**Re: Lot 4 - Filed map 9132  
Tax Id # 135689-6156-02-872849  
Cooper Road  
Town of Wappinger**

Please find the following responses to your October 11, 2022 comment letter, in **bold**.

**Engineer's Report**  
for the redesign of the  
**Water Supply & OWTS**  
for  
**Filed map 9132A - Lot #4**

## TYPICAL 2,500 GALLON PUMP CHAMBER

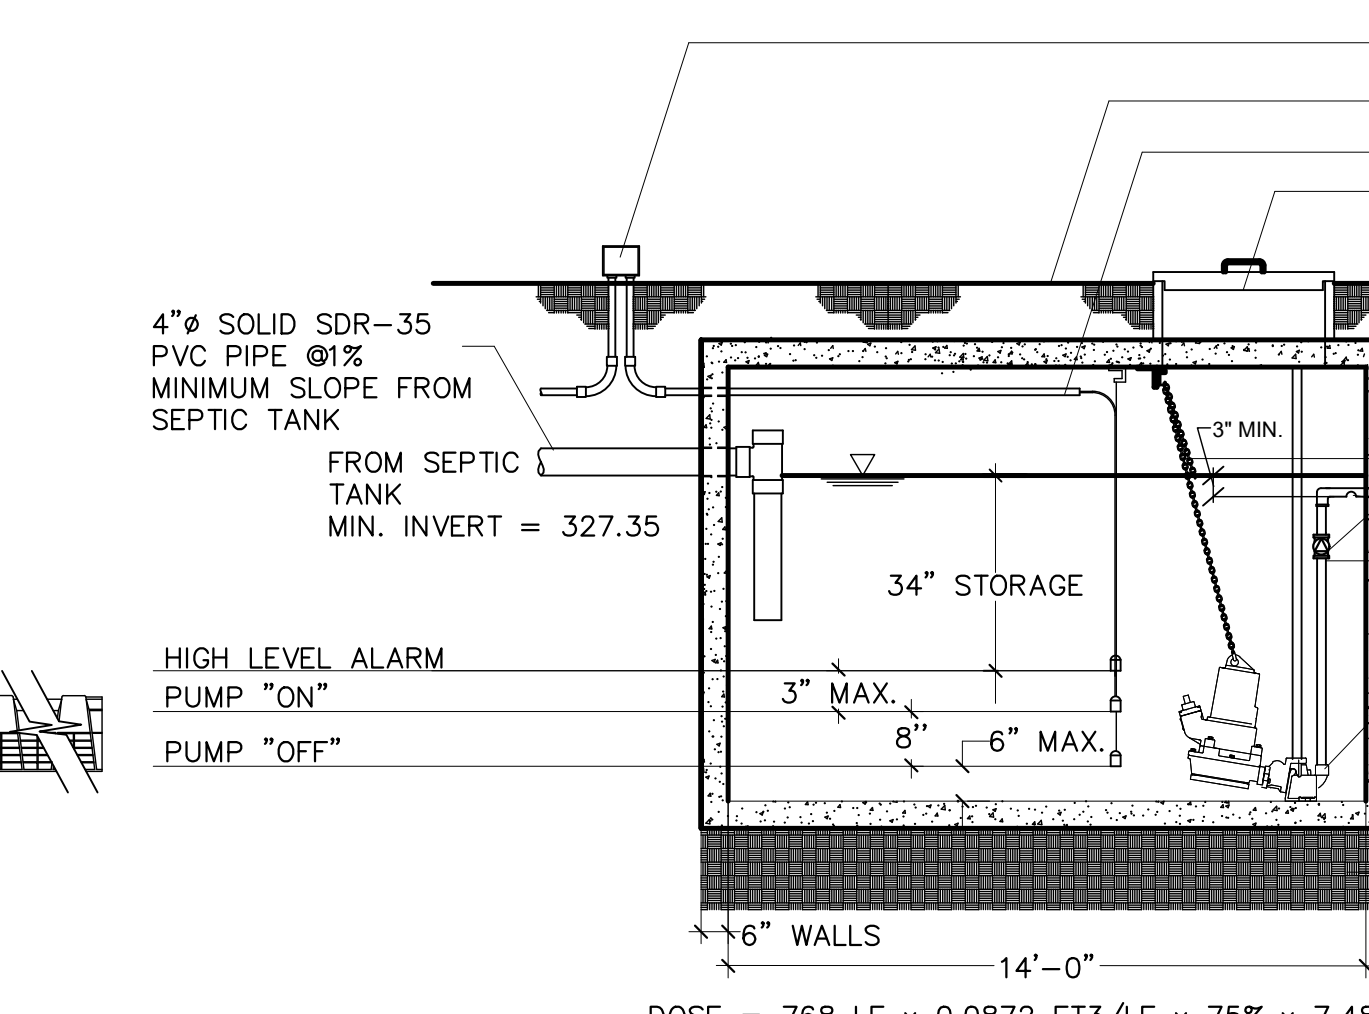
**Revised. The surveyor confirmed this is the correct location.**
9. Deep tests 3 and 4 do not agree with the results recorded by this office (see attached results). Based on the results recorded by this office, it appears a minimum 4' of fill is required for the reserve system, using an 18" maximum trench depth. Please revise the plan accordingly.

**The fill pads have been revised.**
11. The grading illustrated for the primary system does not illustrate 3' of fill throughout the system. Please revise to show additional fill.

16. Due to the proximity of the pump chamber to the building, please revise the detail to specify the vent to be extended to the rooftop to avoid any potential odors.

17. The pump station detail specifies a dose volume of 419 gallons (for primary system) but the tile field schedule appears to indicate a dose of 376 gallons (for primary) and 366 gallons (for reserve). Due to the forcemain length draining back into the chamber, the dose of 419 gallons is preferable for the primary system. Please provide calculations and float settings for the reserve system dose and revise the tile field schedule to provide consistent information on the plan.

19. Please add a note to the pump station detail indicating that all electrical work shall conform to the National Electric Code (NEC), latest edition.

**The force mains have been reconfigured. The head calcs are updated in the revised report.**
15. It is not understood why the plan shows cleanouts on fairly short forcemain runs. Please clarify or remove if these were added unintentionally.

**Revised**

**The dose proposed is 415 gallons; 419 was a typo. The tile field schedule has been updated.**

**Added**

## 2,500 GALLON SEPTIC TANK DETAIL

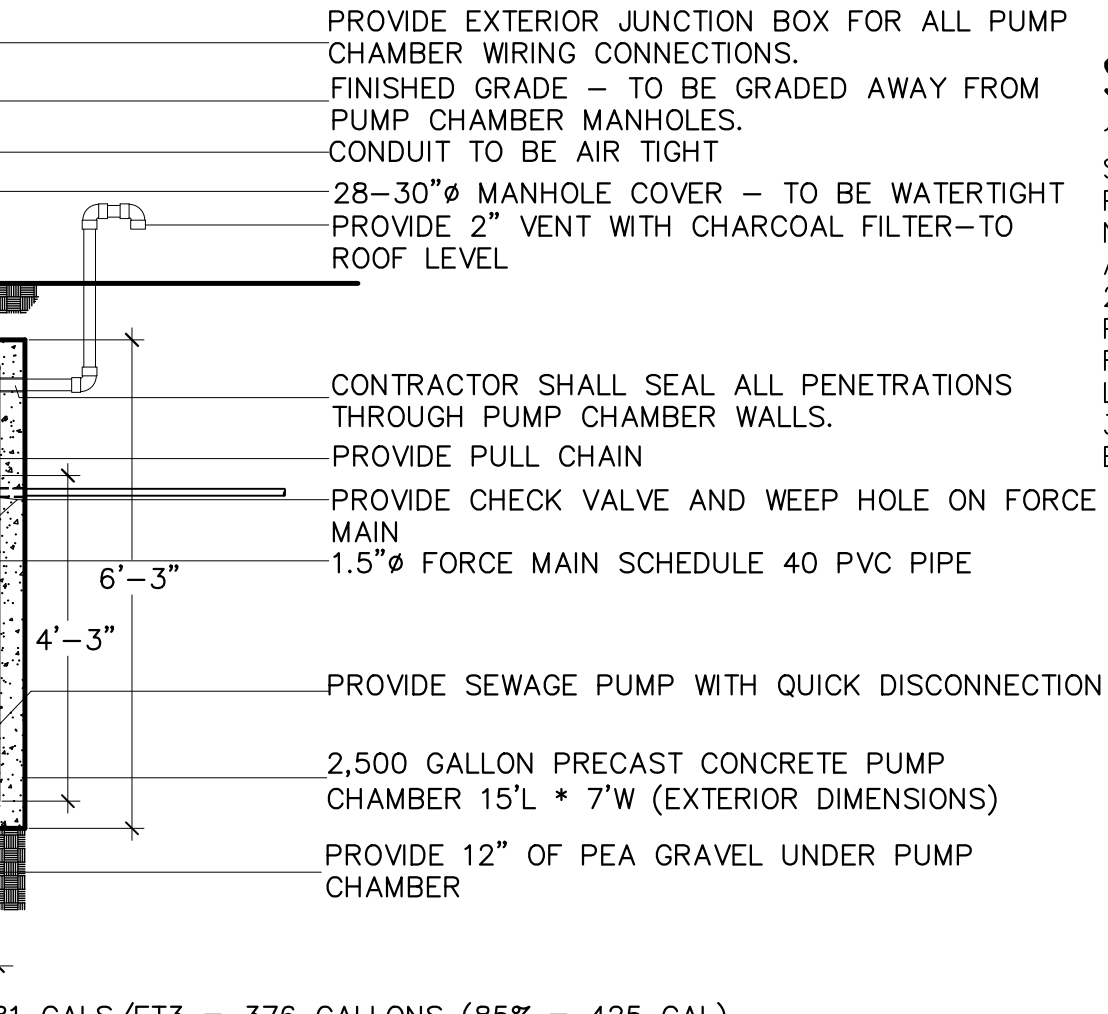
13. It is strongly recommended that manhole risers to grade be added for the septic tank for this project. It is likely that this tank will be pumped much more often than a typical single-family house.

**Risers are now shown on the septic tank detail.**
14. Please revise the plan such that the force mains are not shown exiting the pump chamber at awkward angles. Please illustrate these lines as they will be installed and revise TDH calcs accordingly (if necessary).
